Citizens for the Responsible Development of Outlot A

**Mission: To promote a multi-family unit on
Outlot A**

Remaining Concerns of Resolution 14-03

Density Issue Remains

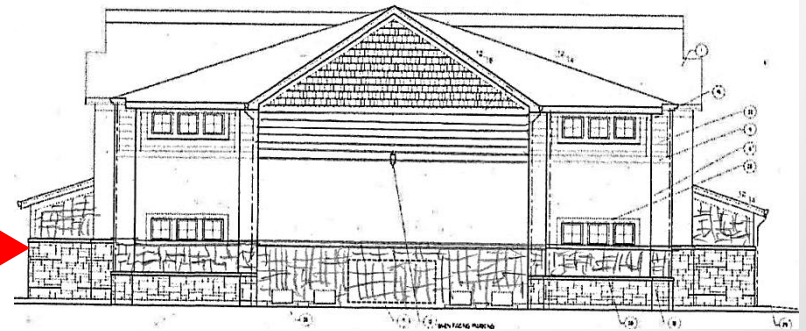
- Buildings have the same dimensions at the widest points
- Visible distance between buildings remains relatively narrow

Density Issue Remains

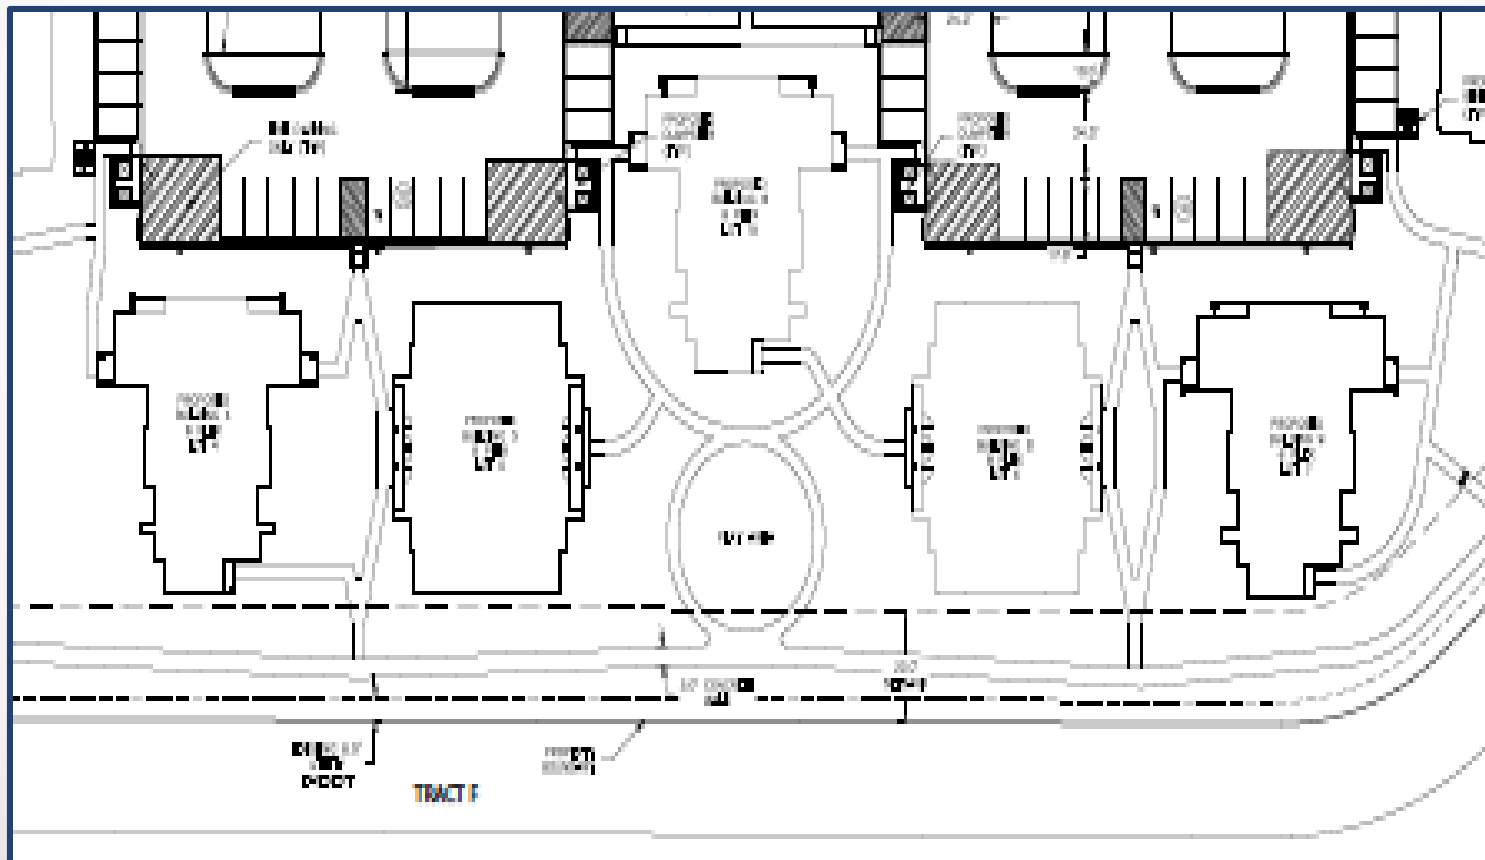
- Dense configuration necessitates the same minimal setbacks from the walking trail and property line

Impact on the City Trail

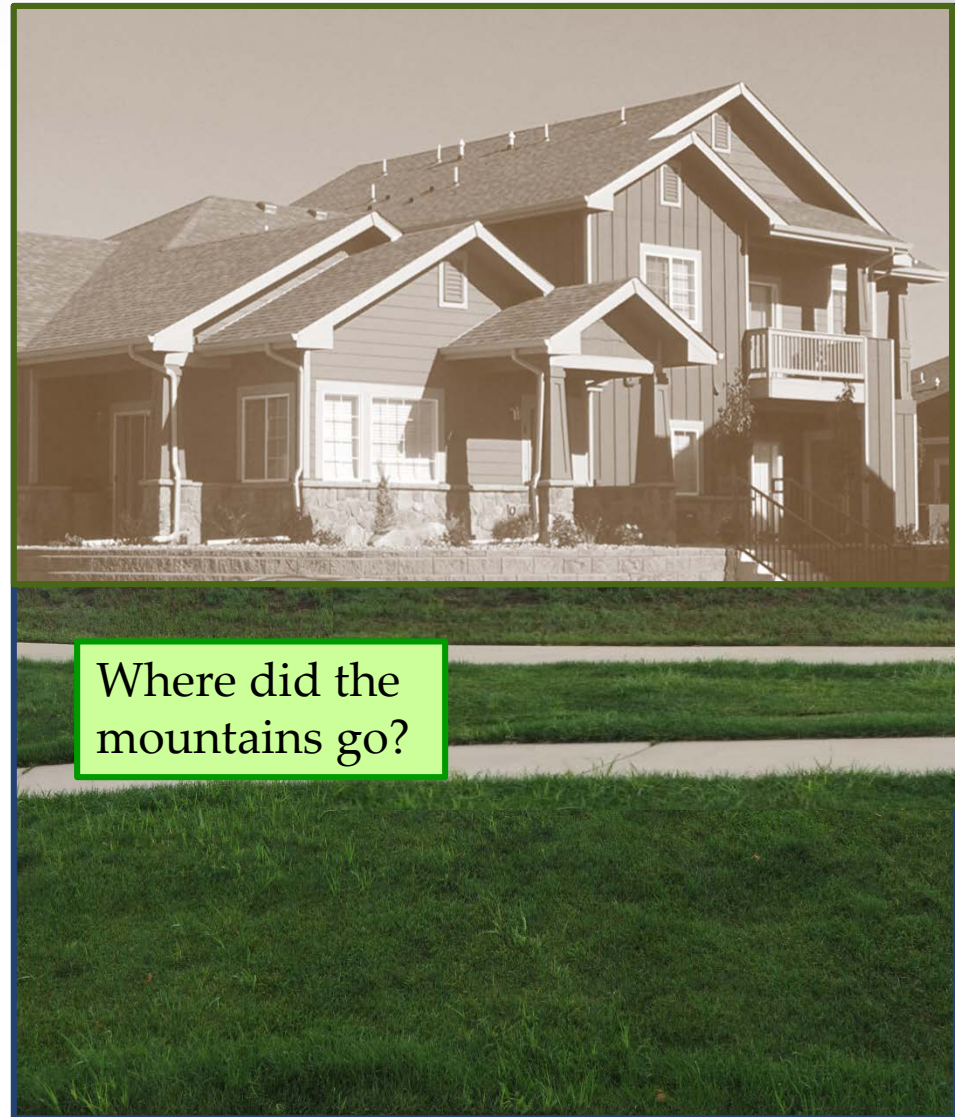
The higher elevation of
Outlot A **intensifies** the
building height.

Projected view of the 6-plex from
the city walking trail

Garage Restrictions

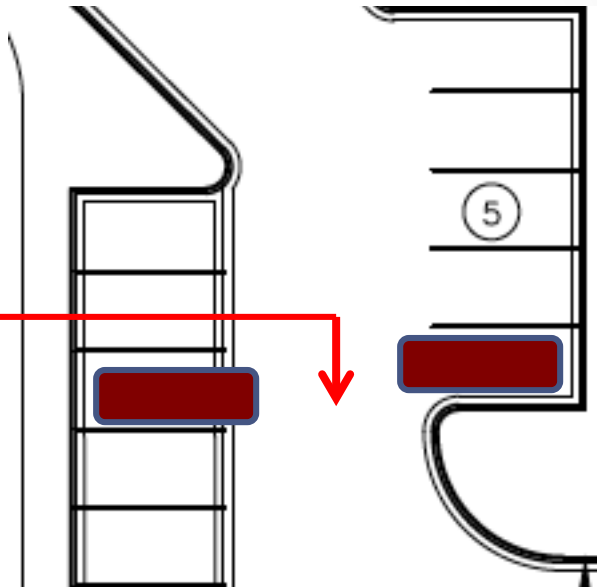
The garage is so narrow, parents will have to **back out of the garage into the drive lane** to put a child in a car seat.

18.5 inches limits the real door opening to less than 12 inches.

SITE PLAN NOTES

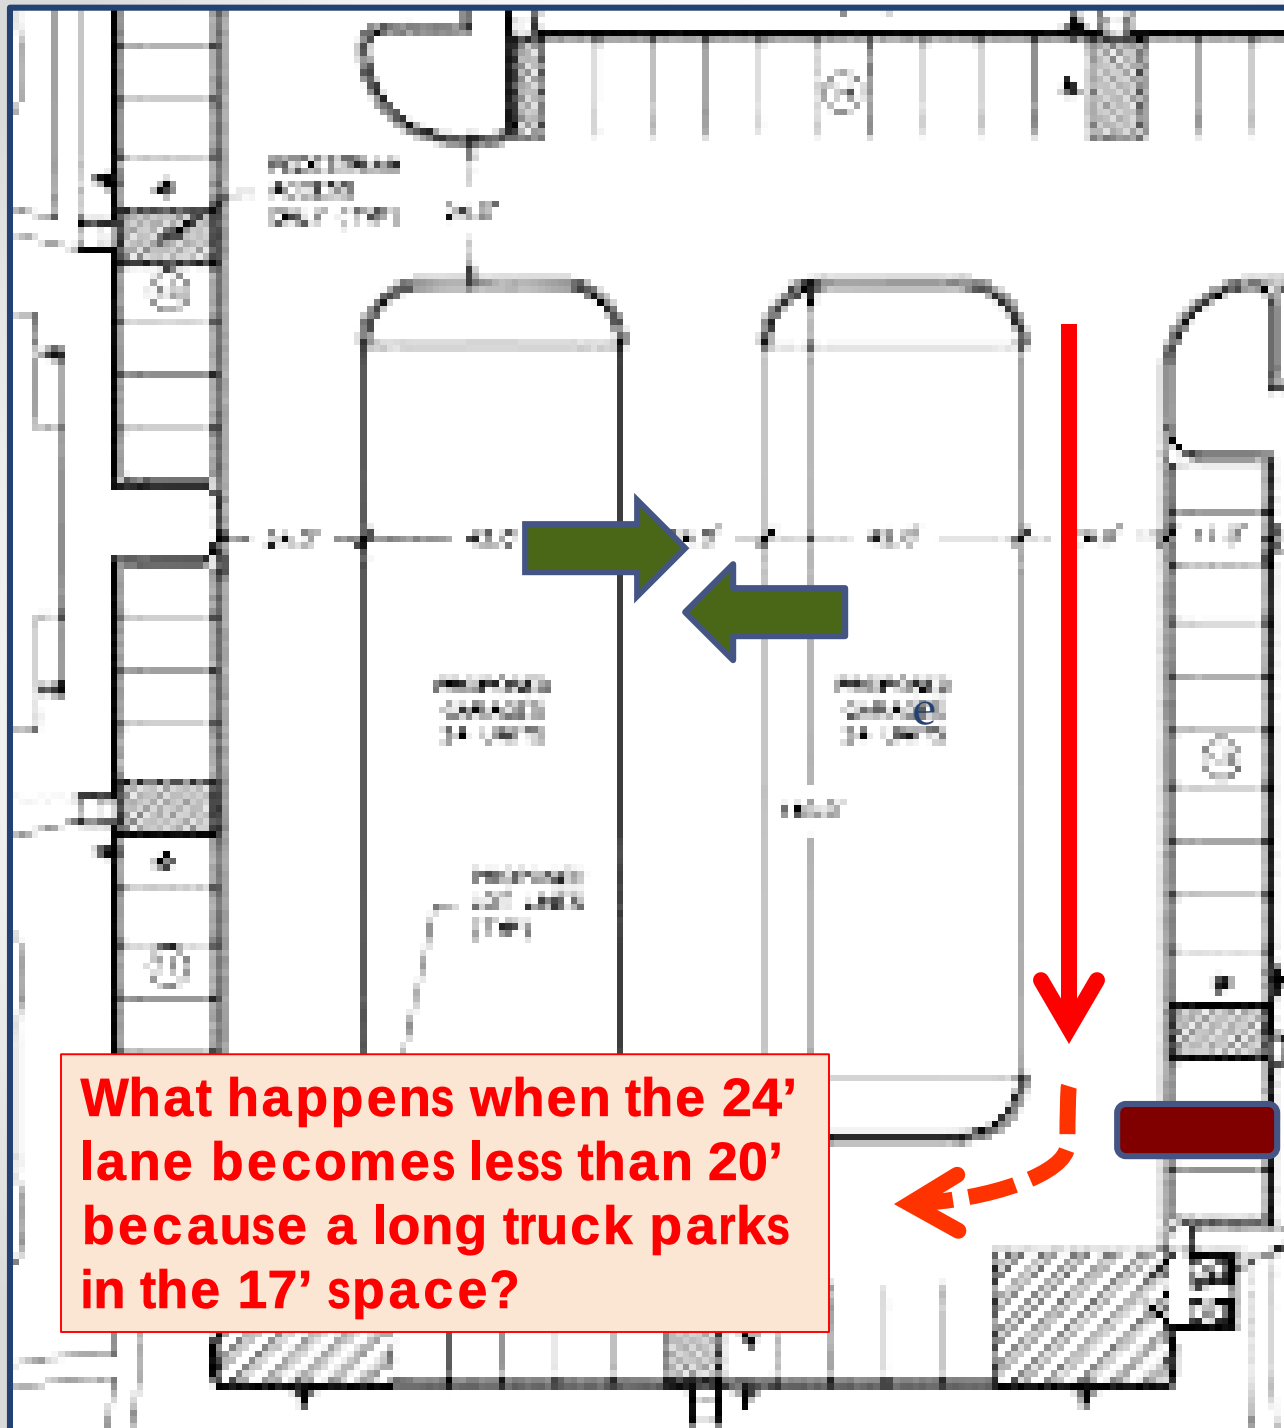
PARKING SPACES DO NOT MEET CITY CODE

CITY CODE: 9' BY 19'; PDP: 9' BY 17'

The adjustment of parking spaces to the correct 19' depth reduces the effective width of the access road to less than the **REQUIRED 20' MINIMUM!**

1. ALL SIDEWALKS ON-SITE ARE 4.0' WIDE CONCRETE UNLESS NOTED OTHERWISE.
2. ALL PARKING STALLS ARE 9'x17' UNLESS NOTED OTHERWISE.

What happens when two garage occupants leave for work at the same time?

What happens when a fire department ladder truck tries to make a corner with a long truck in a parking space?

What happens when the 24' lane becomes less than 20' because a long truck parks in the 17' space?

3.04.03 GENERAL PARKING PERFORMANCE STANDARDS A.

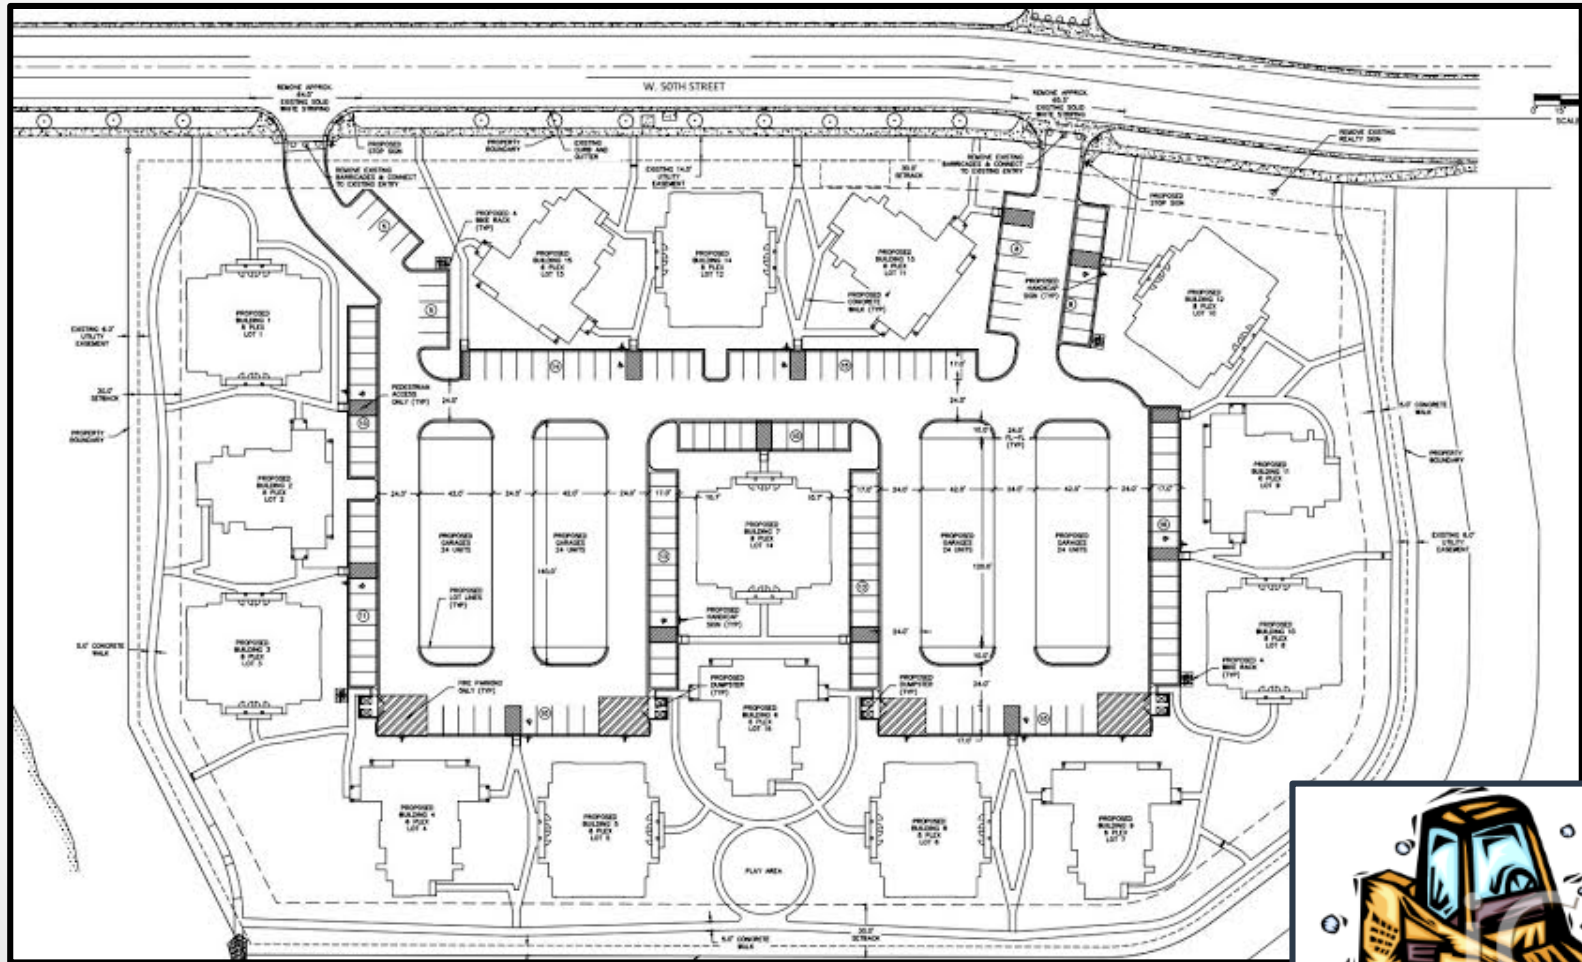
1. Parking shall be designed so that backing and turning movements associated with parking layout **will not obstruct or conflict with traffic, either on - or off-site;**

and B.2. The street, access and parking system shall provide for the **smooth, safe, convenient and functional movement** of vehicles and pedestrians both on - and off-site. Circulation shall minimize the number of vehicular turning movements **and points of vehicular conflict, particularly at access points;**

1. Two cars attempt a left turn off 50th into the development.
2. Car 1 (blue) turns, but must stop suddenly as Car 2 (green) backs out).
3. Car 3 (red) stops in the on-coming lane to avoid running into Car 1 (blue).
4. Car four (yellow) hits Car 3 (red).

Proposal's 'Green Spaces'

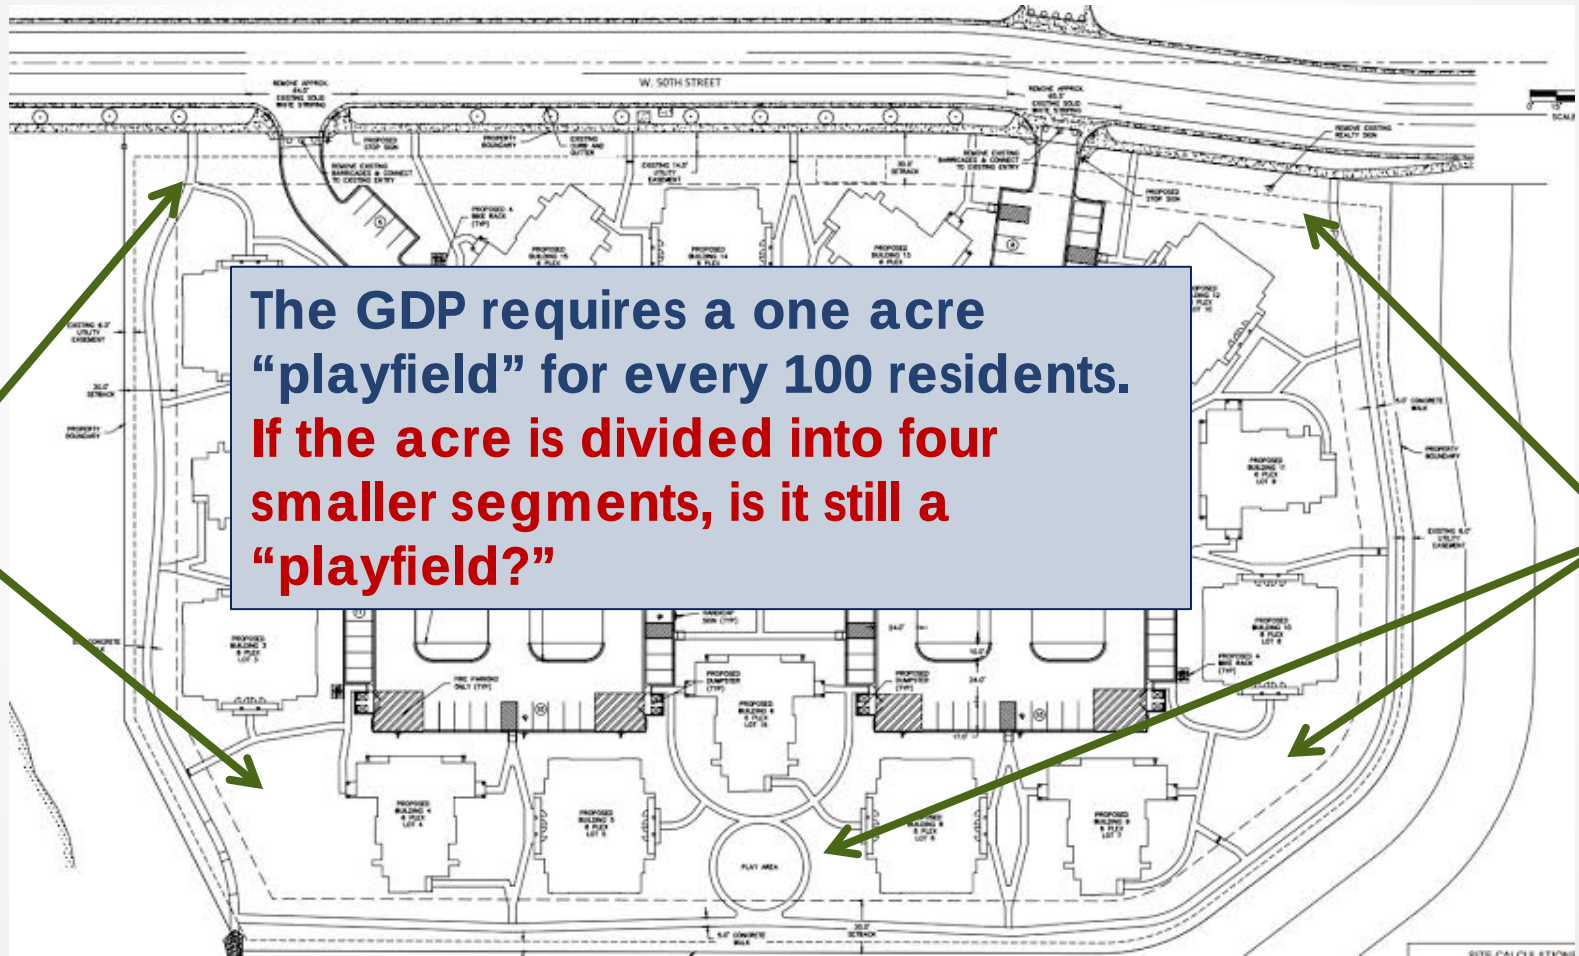
The GDP requires a one acre “playfield” for every 100 residents.
If the acre is divided into four smaller segments, is it still a “playfield?”

The GDP does not allow the developer to include the setbacks in the computation of green space.
